BLUFFS AT CYPRESS CREEK SUBDIVISION, **PHASE TWO**

APPLICATION NUMBER 12 DATE July 19, 2018

APPLICANT Bluff's at Cypress Creek Subdivision, Phase Two

REQUEST Subdivision

DETAIL SITE PLAN

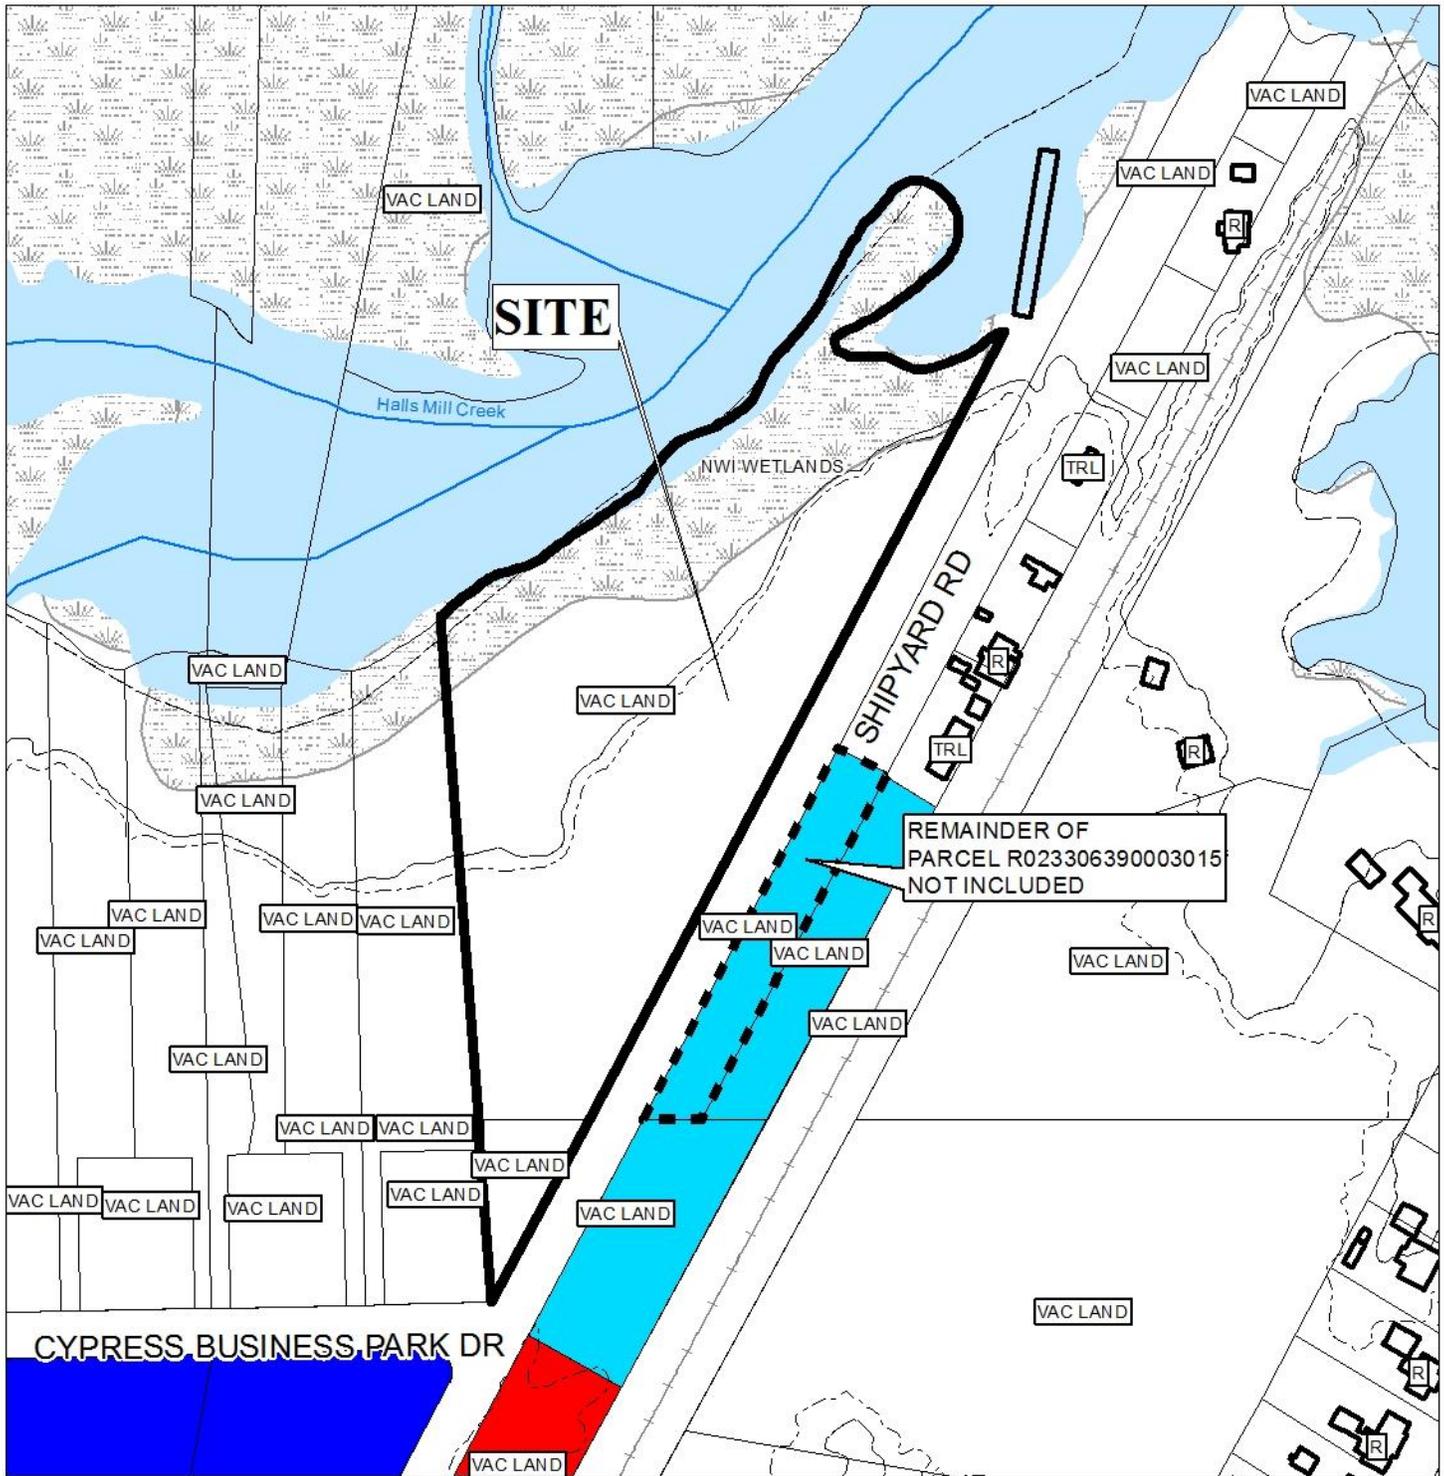
- A. Provide all of the required information on the SUBDIVISION PLAT (i.e. signature blocks, signatures, certification statements, written legal description, required notes, legend, scale, bearings and distances) that is required by the current Alabama State Board of Licensure for Professional Engineers and Land Surveyors.

- B. Show and label the recording data for the parcel shown as PARCEL C - COMMON AREA NOT INCLUDED.
- C. Provide the recording data for the vacated ROW.

- D. The City GIS indicates that that this parcel is adjacent to a ROW. Show and label Shipyard Rd. and the existing ROW width.
- E. Provide additional detail for the proposed front property lines at the south end of the LOTS near the intersection of Cypress Business Park Dr.

- F. National Wetlands Inventory (NWI) mapping, as shown on City of Mobile GIS information, indicates that there is potential for wetlands within the property or properties shown on this plat. Show and label the delineated wetlands, or provide a note that the wetlands shown on this plat are scaled from the NWI data and have not been delineated.

- G. Show and label the MFFE (Minimum Finished Floor Elevation) on each lot that contains an AE, V, or X (shaded) flood zone designation or revise NOTES #8 to include the LOT numbers.

- H. Show and label each and every Right-Of-Way and easement.
- I. Provide and label the monument set or found at each subdivision corner.
- J. Provide the Surveyor's, Owner's (notarized), Planning Commission, and Traffic Engineering signatures.

Traffic Engineering Comments: Lot 44, Lot 45 and Lot 46 are limited to one shared curb cut to be located at the further limits of the improved roadway as illustrated on the subdivision plat (100' beyond the end of the existing roadway). Access to the unimproved roadway from Lot 46

is denied until the roadway is improved to City standards. Driveway size, location and design to be approved by Traffic Engineering and conform to AASHTO standards.

It should be noted that the design of the subdivision excludes a portion of one of its parent parcels that is labeled as “Common Area Not Included” on the preliminary plat. As such, holdover of the request may be appropriate to allow the applicant to include the remainder of the parcel from which the subject site is proposed to be subdivided.

The proposed lots each have frontage along Shipyard Road, an unimproved minor street without curb and gutter requiring a 60’ right-of-way. It appears that Shipyard Road has an existing right-of-way of 60, making dedication unnecessary.

No right-of-way is illustrated along Shipyard Road, thus the plat should be revised to provide dedication at least 30’ from the centerline of Shipyard Road, if approved, and no dedication is necessary along the vacated railroad right-of-way.

Each of the Lots is irregularly shaped and may be regarded as “panhandle” lots, a design discouraged by Section V.D.1. of the Subdivision Regulations; the exception being the approval of lots located where varied and irregularly-shaped lot designs are common, and the informality of design is consistent with other lots in the vicinity. Considering the site is located along a waterway, and in an area of heavy commercial zoning, this type of lot design is often used in industrial developments and is not uncommon with other residential lots in the vicinity of the subject site. Additionally, the Planning Commission approved similar lot designs in Phase One of the subdivision, thus approval of the request may be appropriate with a waiver of Section V.D.1. of the Subdivision Regulations. It should be noted, however, that the width of the “panhandle” should be revised to be a minimum of 25’ for each lot.

Lots 44 and 45, as proposed, exceed the maximum width-to-depth ratio of Section V.D.3. of the Subdivision Regulations. Revision to the design of these lots may resolve this issue, but if approved, a waiver of Section V.D.3. will be required.

The lots meet the minimum size requirements for lots served by public water and sanitary sewer systems, but are only labeled with their sizes in acres on the preliminary plat. As such, revision of the plat to provide the sizes of each lot in both square feet and acres should be required, if approved; or, provision of a table on the Final Plat providing the same information may suffice.

Dedication of the corner radius at the intersection of Cypress Business Park Drive and Shipyard Road is illustrated, in compliance with Section V.D.6. of the Subdivision Regulations, and should be maintained on the Final Plat, if approved.

The 25' minimum setback line is not illustrated on the plat for any of the proposed lots, as required by Section V.D.9. of the Subdivision Regulations. As such, revision of the plat to illustrate the 25' minimum building setback line where each lot is at least 60' in width should be required, if approved.

A 50' Alabama Power Company easement is illustrated running from the Southwest to the North of the proposed subdivision. As such, if approved, a note should be placed on the Final Plat stating no structures shall be constructed in any easement.

- 1) revision of the "panhandle" for all lots to be a minimum of 25'-wide;
- 2) revision of the plat to illustrate the 25' minimum building setback line where each lot is at least 60' wide; and,
- 3) submission of a revised preliminary plat to include the remainder of the parcel from which the site is proposed to be subdivided, including additional fees and mailing labels, if necessary.
